3717 s alaska st

Design Review - 2nd Recommendation

June 7, 2016

SDCI Project # 3019517

ENLARGED PLAN AT RAINIER

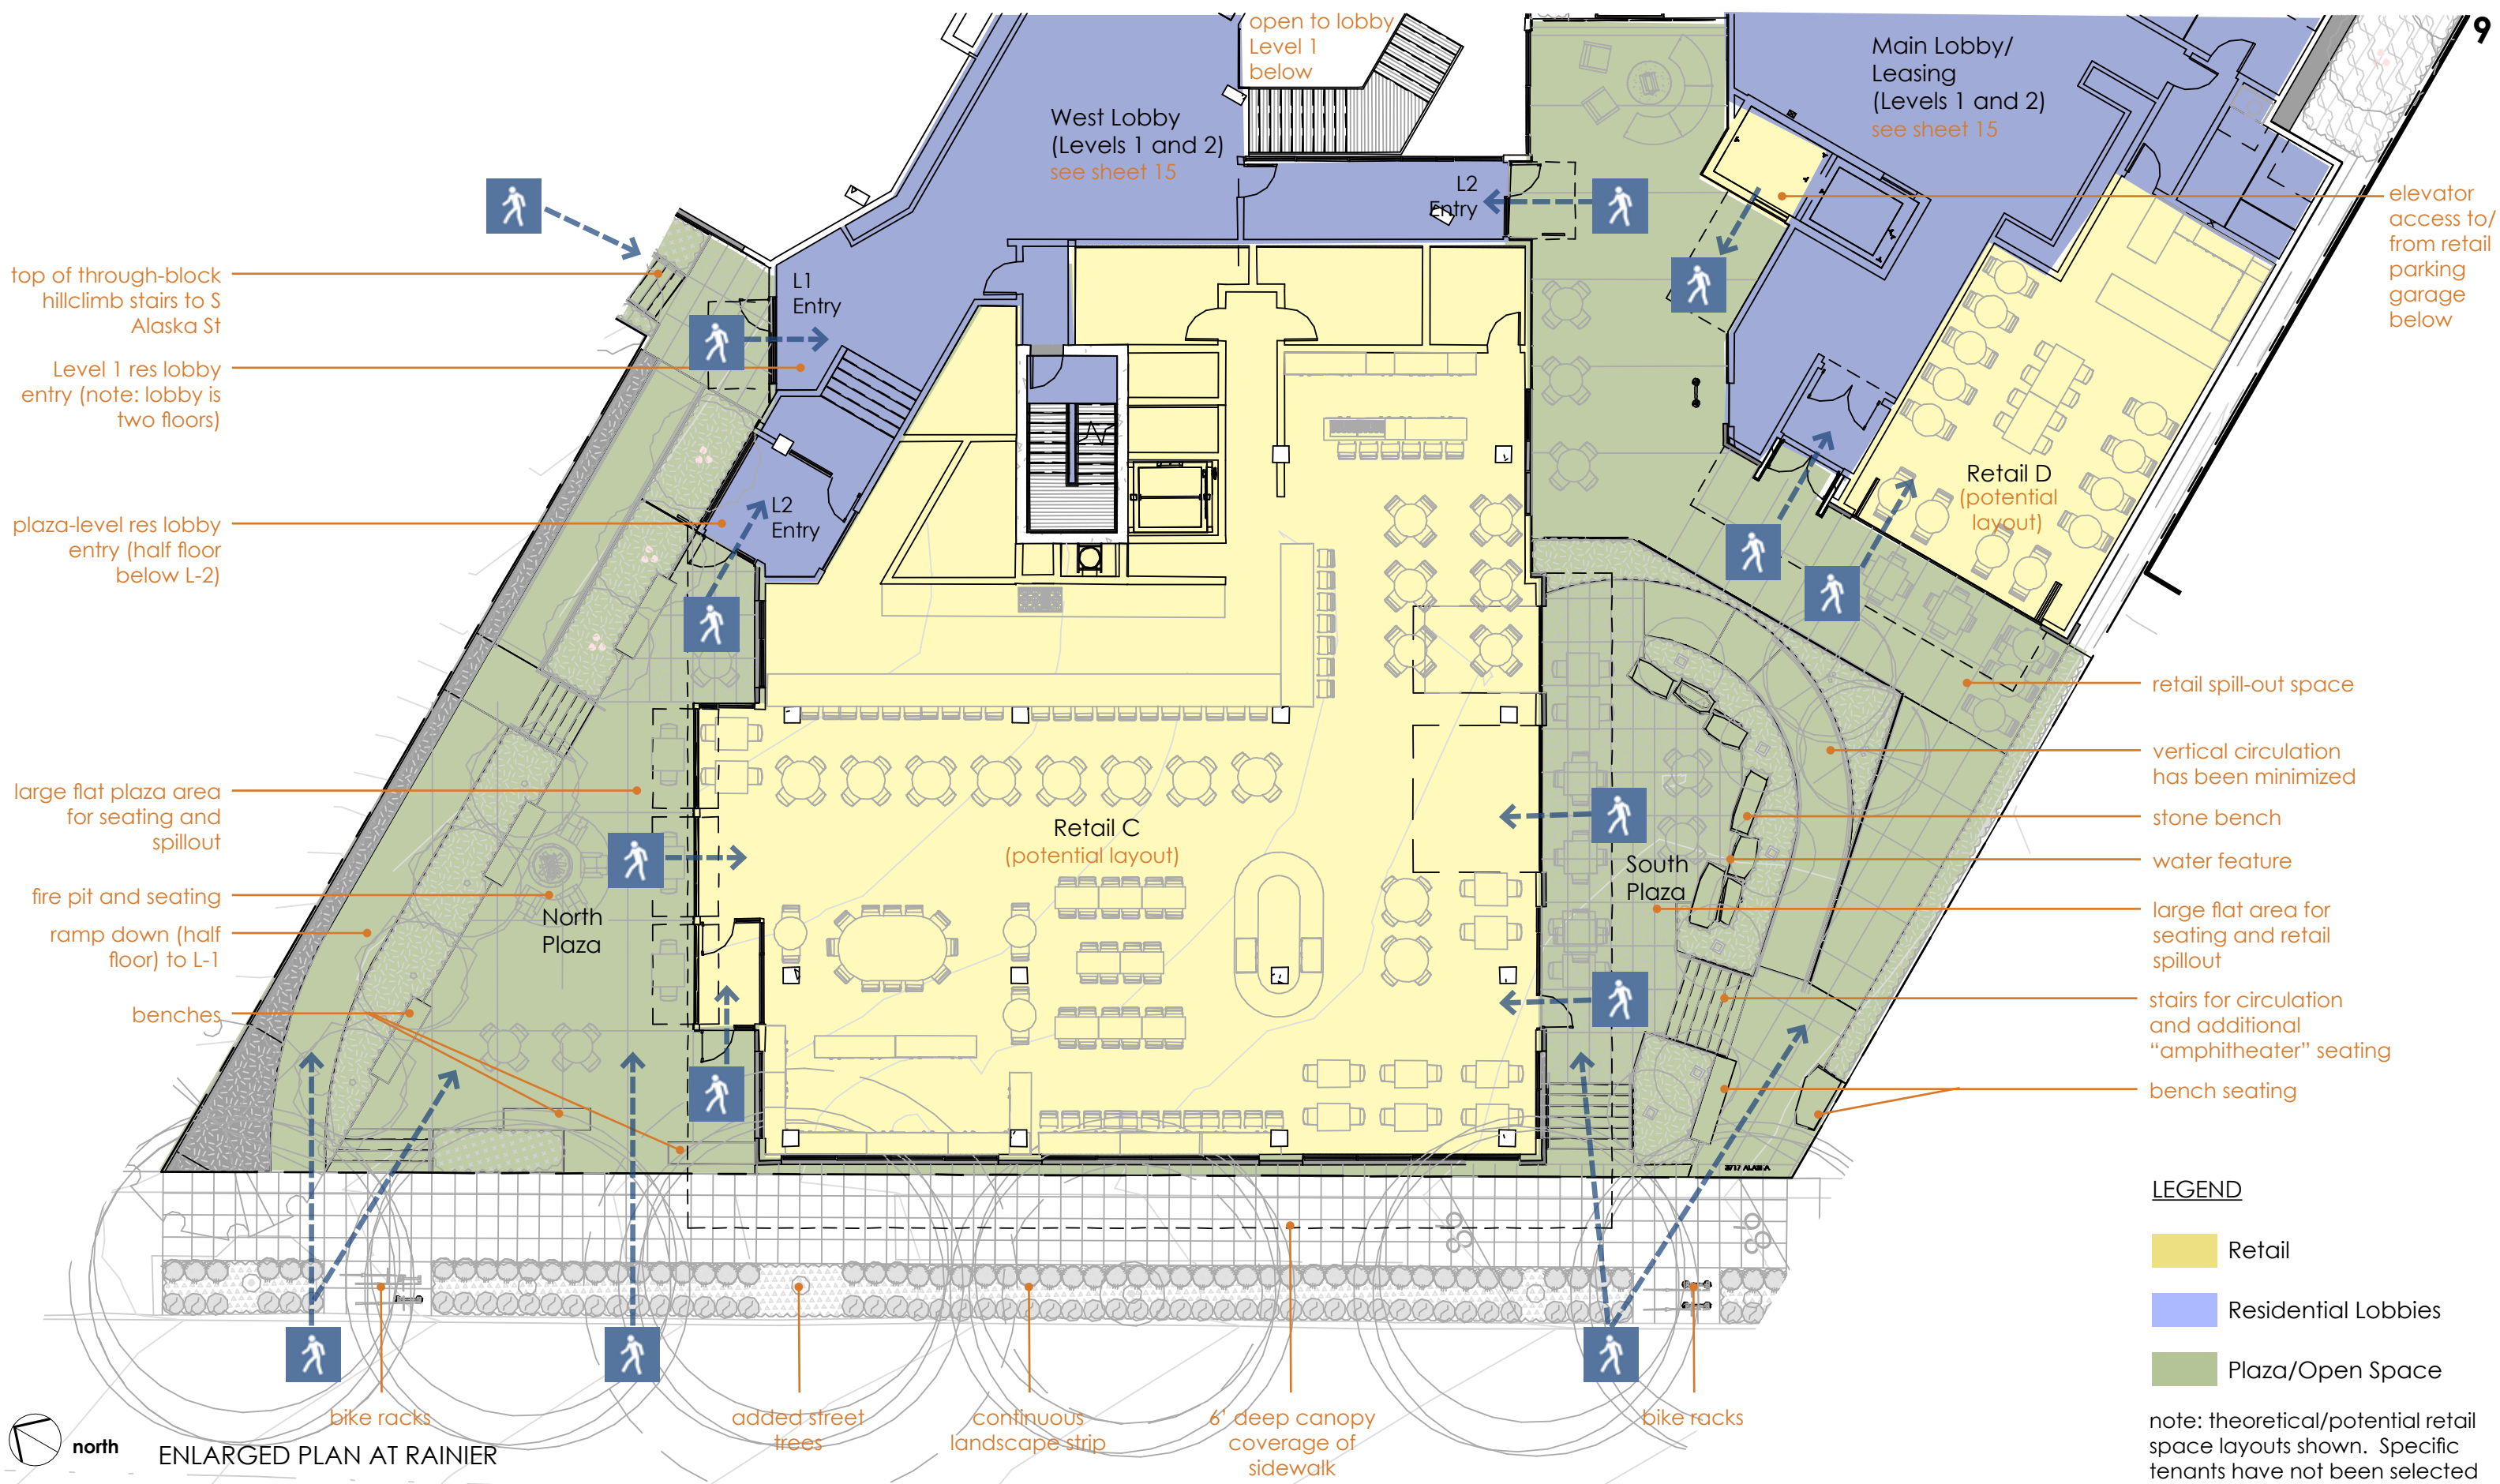
- Board Guidance: concerned with the amount of plaza space dedicated to circulation; provide additional space for seating and retail spill-out

- Board Guidance: provide street furniture and pedestrian amenities along the streetscape to engage and foster human interaction

- Board Guidance: questioned whether the Rainier-facing facade was over-articulated and requested greater canopy coverage of the sidewalk and sidewalk against the building edge

Design Response: Circulation space has been simplified and consolidated to allow more flat usable plaza space for seating/spill-out.

Design Response: Benches and bike racks are provided at the front of each entry plaza to engage pedestrians along the street frontage (see Pg 9).

Design Response: Building mass and Retail C frontage has been pulled forward to meet the sidewalk for a more direct connection to Rainier and greater overhead canopy coverage. Rainier-facing facade has been simplified by eliminating projecting balconies and unifying the retail base with the brick facade above to allow the open space to be the focus.

ENLARGED HILLCLIMB PLAN

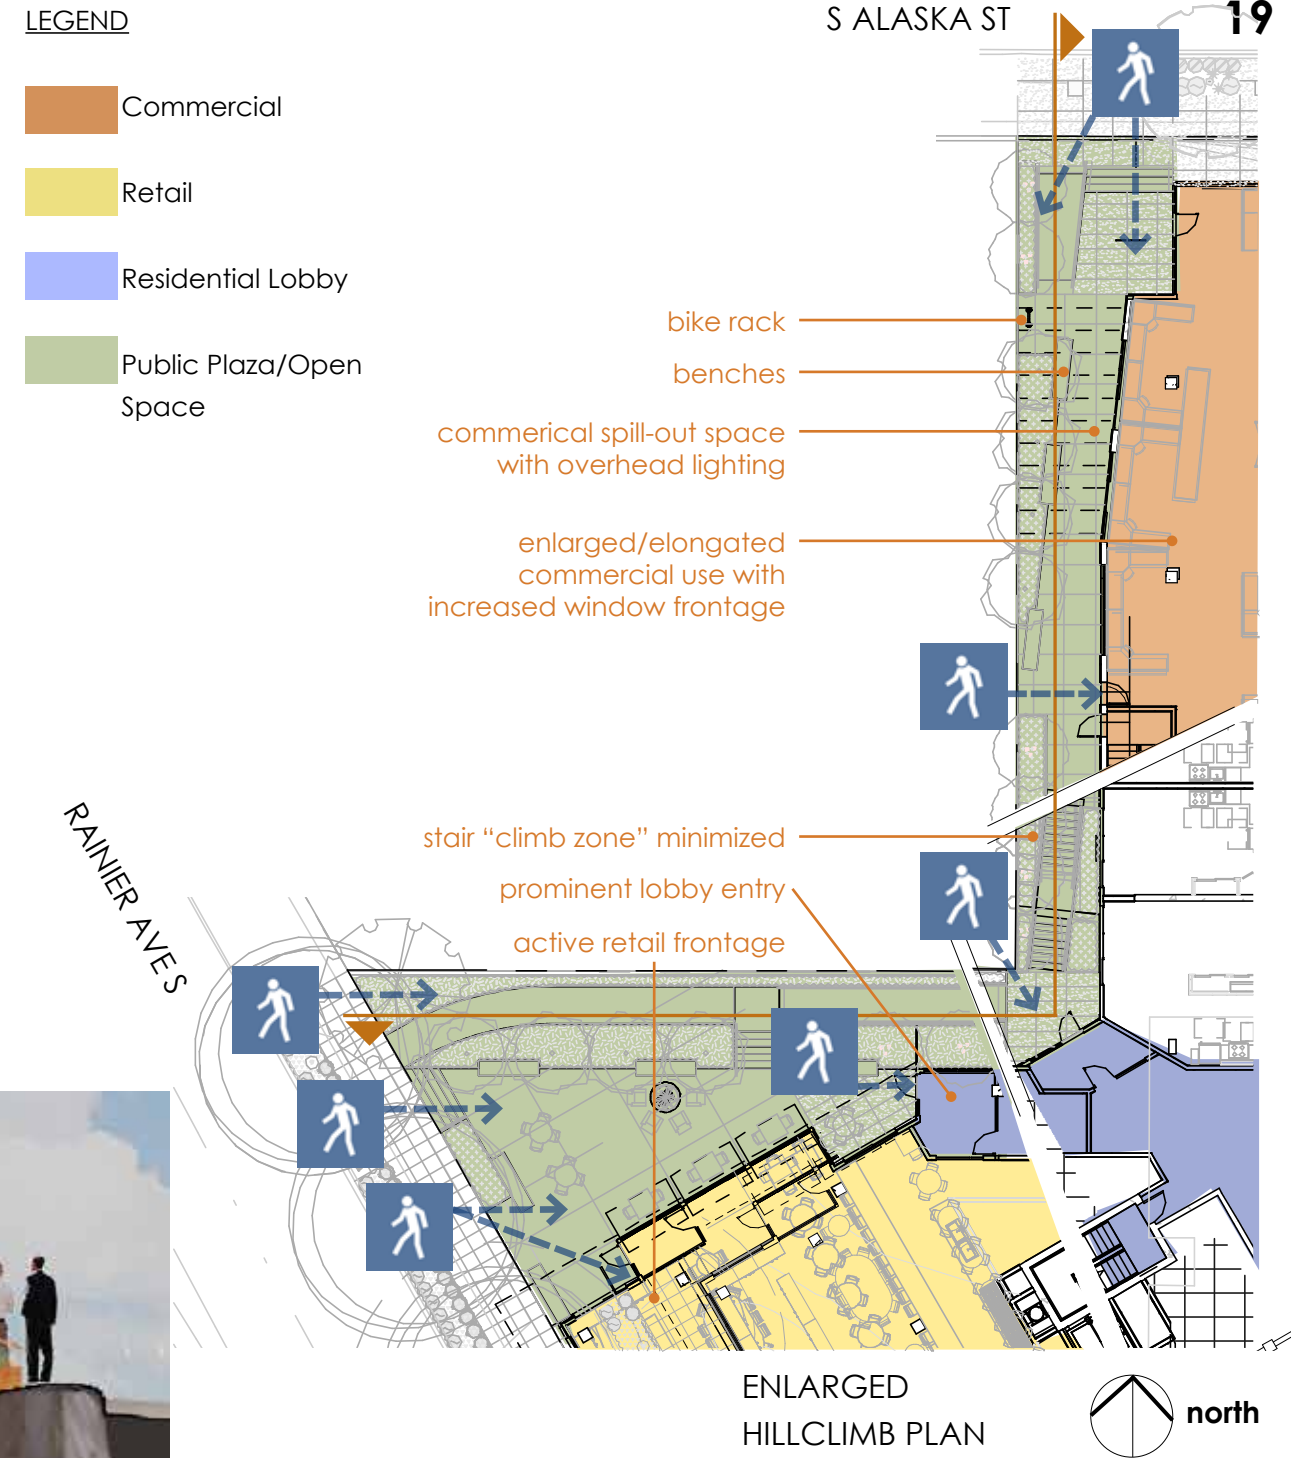
- Board Guidance: Further develop the hillclimb open space, adjacent frontages, and secondary lobby to create pedestrian-oriented edges. Maximize quantity of glass facing the hillclimb for safety/security and ground-level interaction

- Board Guidance: safety and security are important considerations at the hillclimb

Design Response: The commercial use adjacent to the hillclimb has been significantly expanded in size (by 1200sf) for a stronger presence and increased frontage length and fenestration facing the through-block connection. The stairclimb zone has been consolidated to maximize flat/useable open space within the hillclimb and encourage spill-out use/activation by the commercial space. Residential unit frontage (a less active use) has been reduced. The residential lobby entrance has been enhanced in the north plaza by projecting it out and using an accent siding material to provide a stronger anchor/landmark at the top of the hillclimb stairs for wayfinding. Accent pre-weathered steel siding added along the hillclimb building base to break up perceived height and provide a higher-quality material at the pedestrian level.

Design Response: treating the hillclimb as an additional "streetscape," built-in benches and bike racks are provided at the top and bottom to encourage pedestrian interaction and human activity (see pg 19). Ample building mounted, overhead, and landscape lighting will brightly illuminate the area at nighttime.

NEW DESIGN of NE Corner showing increased ground floor setback @ Alaska & 38th intersection

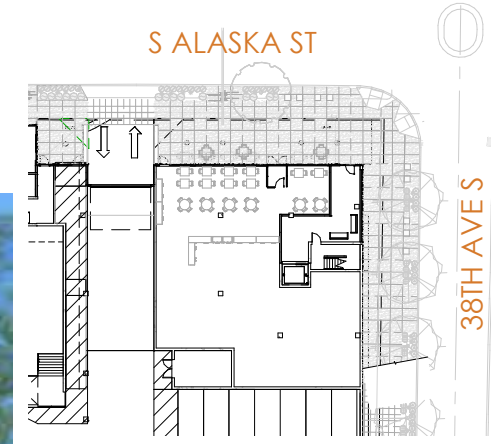
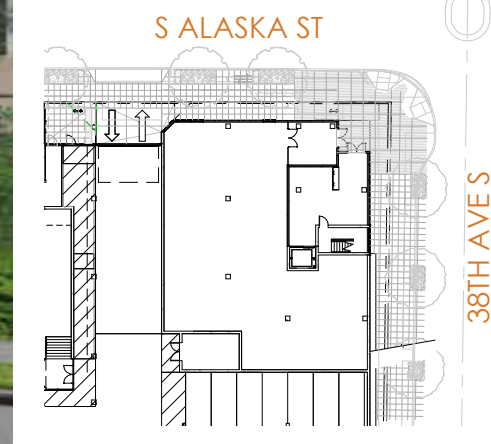
- Board Guidance: to address height, bulk, and scale concerns, consider setting back the top two floors at the NE corner

- Board Guidance: to enhance sightlines/ground level visibility, consider expanding NE ground floor setbacks

Design Response: upper two floors at the NE corner have been set back fronting S Alaska St and 38th Ave S. The brick base reflects the scale of the existing 5-story multifamily neighbor.

Design Response: ground floor set back has been increased 8' (from 6' to 14') from Alaska sidewalk and is 6' back from 38th sidewalk at the NE corner

Facade Modulation along S Alaska St (North Elevation)

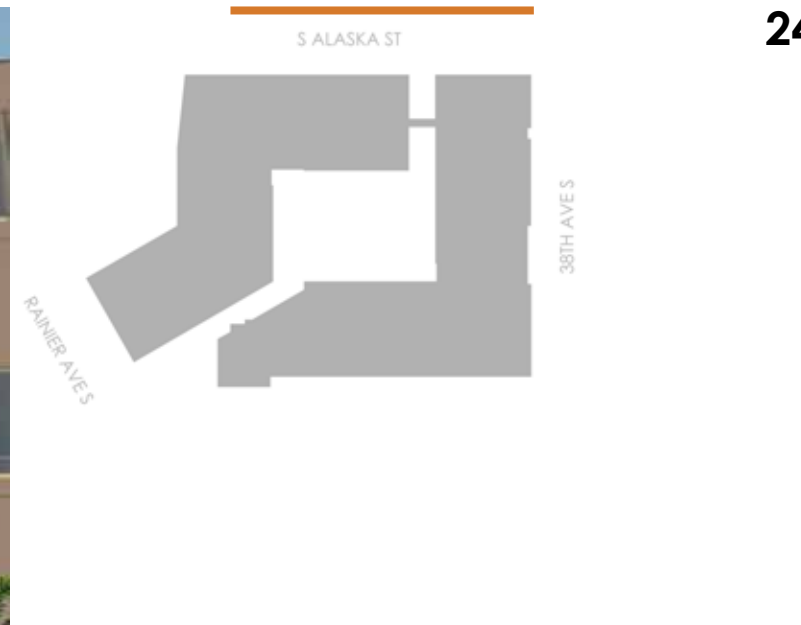
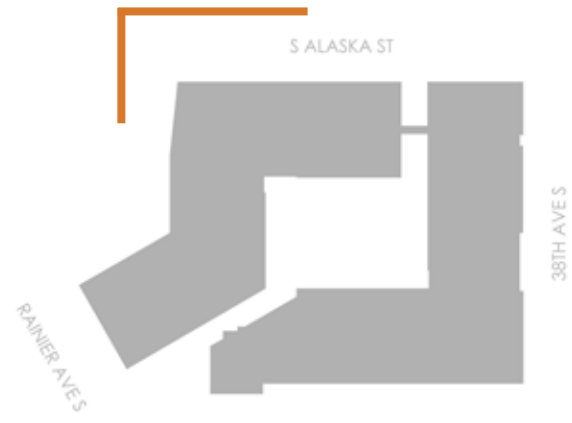
- Board Guidance: Due to concerns about the lack of modulation at dark grey portions of S Alaska (west end) and 38th Ave S (mid-block), consider adding secondary articulation/detail and pulling the storefront expression on 38th up one level to increase the perceived height of the ground floor

Design Response: At S Alaska St, modulation with a second paint color was added along the previously unbroken western building, punctuated with bolt-on balconies. At 38th Ave S, the building base along the midblock portion has been raised one story and the ground floor adjacent to the retail frontage is set back from the sidewalk, resulting in increased sidewalk width and a reduction in scale of the mid-block cement board siding mass. Additional bolt-on balconies have been added above the residential garage entry on 38th for enhanced texture and human-scale secondary articulation
